February 15, 2011

RE: Response to Additional Comments
Phase 3 Tuscarora Municipal Solid Waste Landfill (MSWLF) Craven County, North Carolina
Permit No. 25-09
JEI Project No. 618.0900.11, Task 05

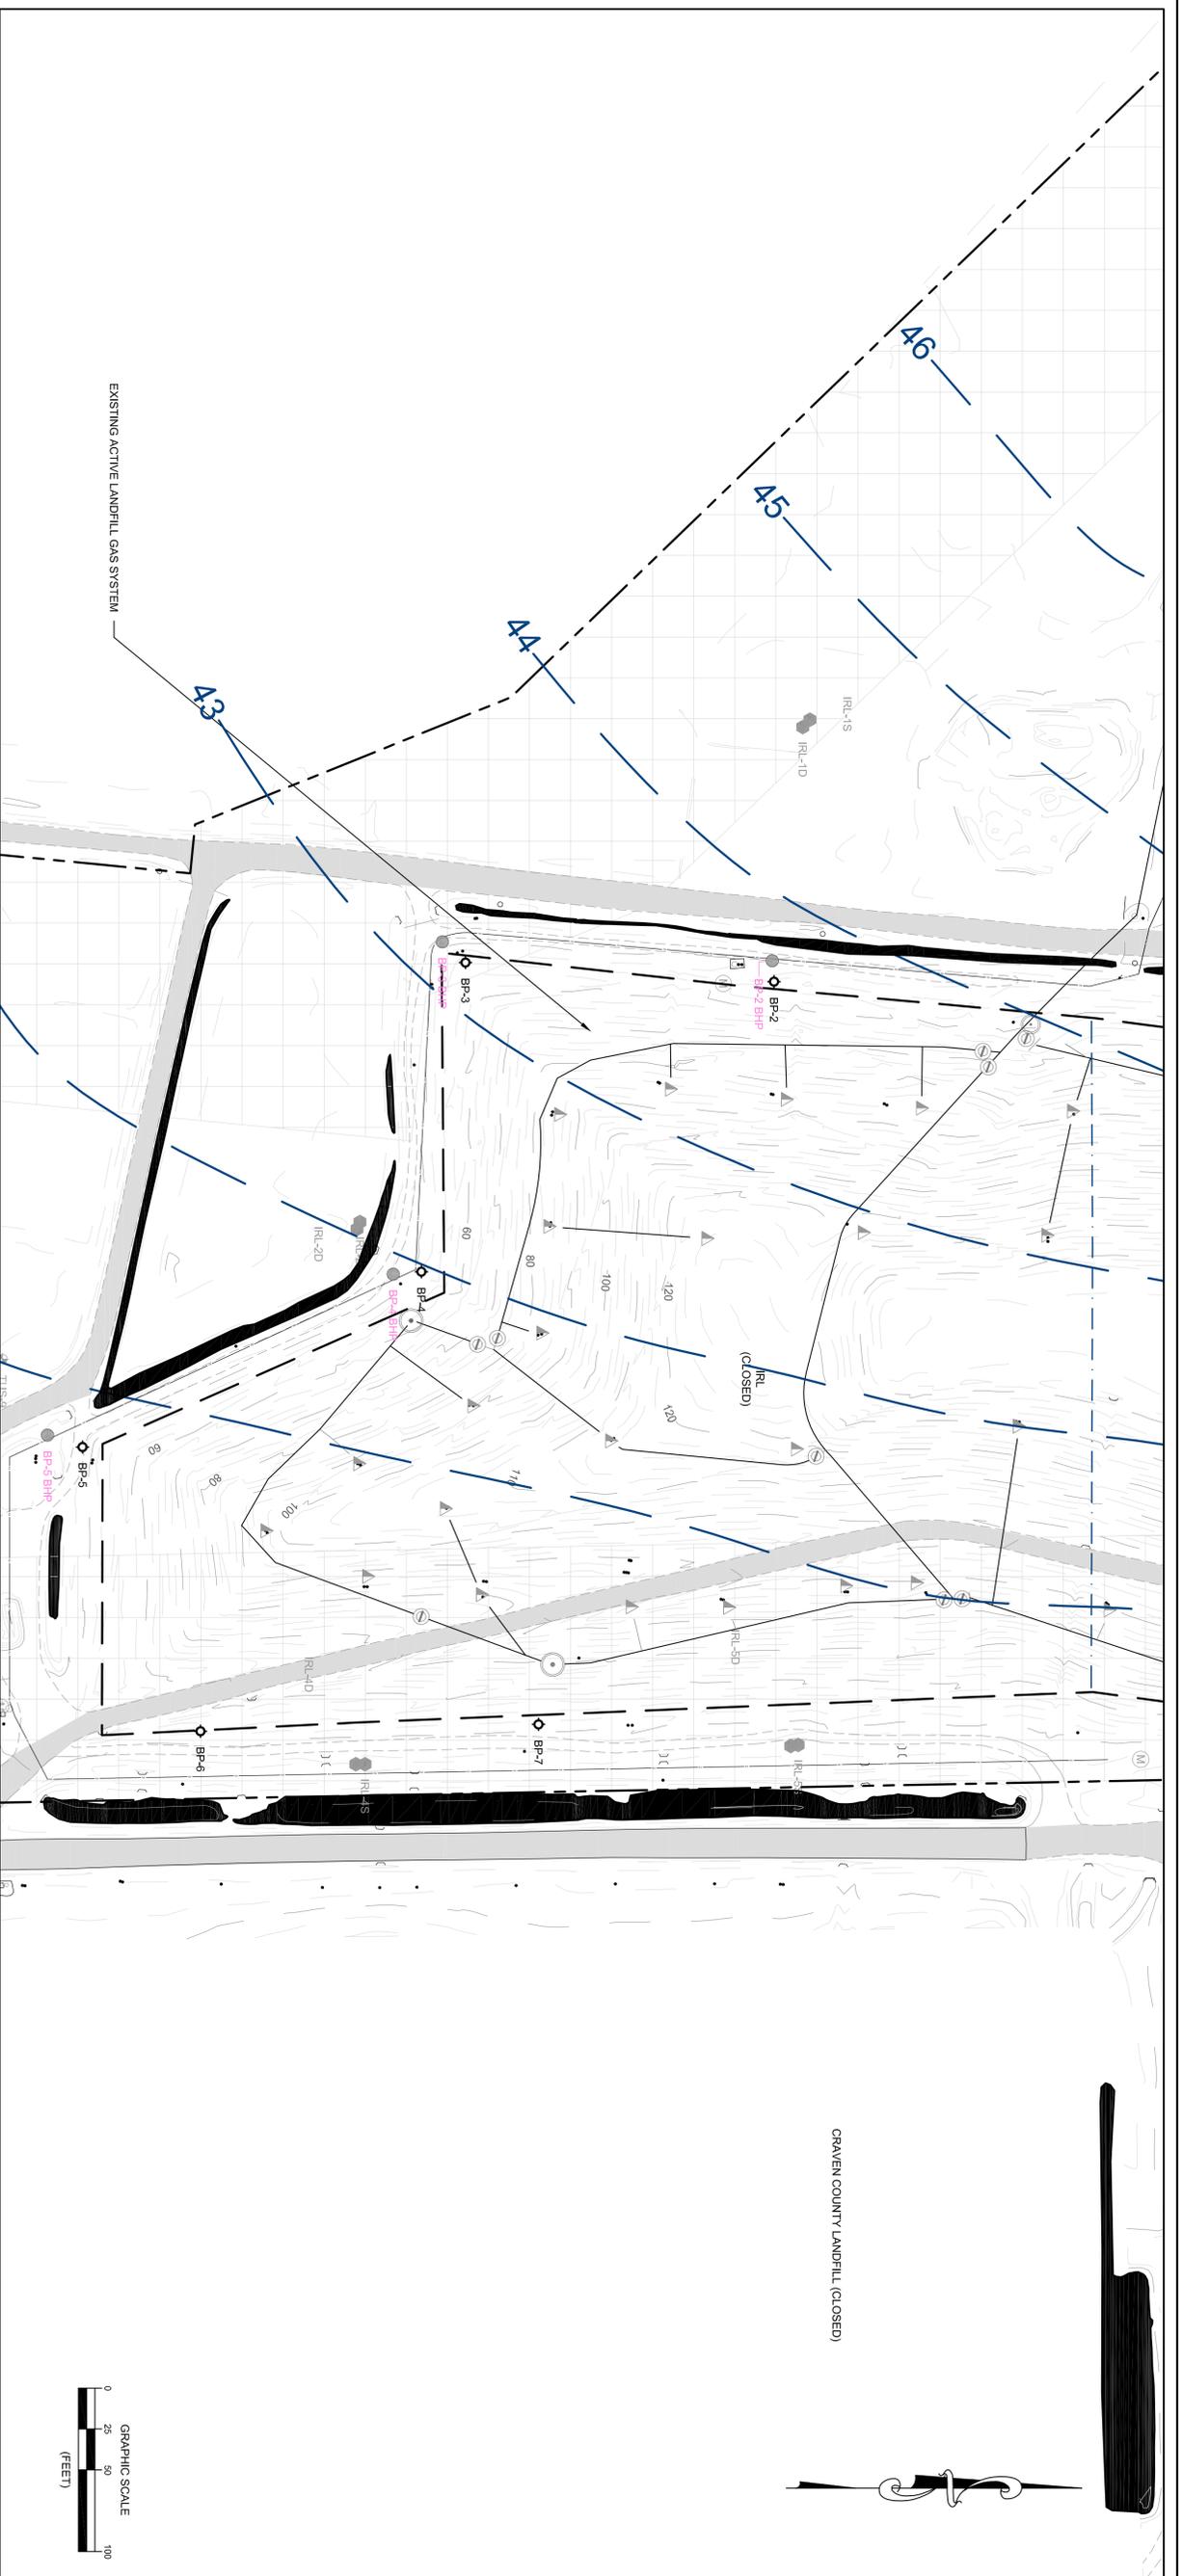
We request further information and investigation regarding the elevated methane readings detected in BP-2, BP-3, BP-4, and BP-5 located to the southwest of the closed IRL portion of the landfill. The letter stated that bar-hole punches were installed and readings taken 20 to 25 feet away from each of the detection probes showing elevated readings. The letter states that the subsequent bar-hole punches showed no elevated methane readings and concluded that there is "no evidence of gas migration". Please submit a map with the bar-hole punch locations and respective methane readings. A statement was also made in the letter attributing the elevated methane readings to "IRL leachate drainage penetrations through the liner, the leachate cleanout pipes and water level transducers penetrations through the cap". Please clarify this statement with explanations on whether the liner is leaking, whether gas probes were installed through the liner, etc.

The gas probes *BP-3, BP-4, and BP-5* with elevated methane readings on the southwest side of the IRL are not well understood and further investigation is warranted. The elevated readings are merited to the gas probes immediate proximity to the landfill and adjacent wetland with organic decay and production of swampgas.

The IRL is a separate landfill unit from the Regional Long-Term Facility, and we propose further investigation, as requested by the Section, during the Phase 3 construction to gain an understanding to the elevated methane readings from the IRL probes. Attached map depicts the gas probe and the bar-hole probes locations. The leachate cleanout pipes and the pressure transducers penetrate the closure cap; therefore, the penetrations do not pose threat to leachate leakage through the bottom liner.
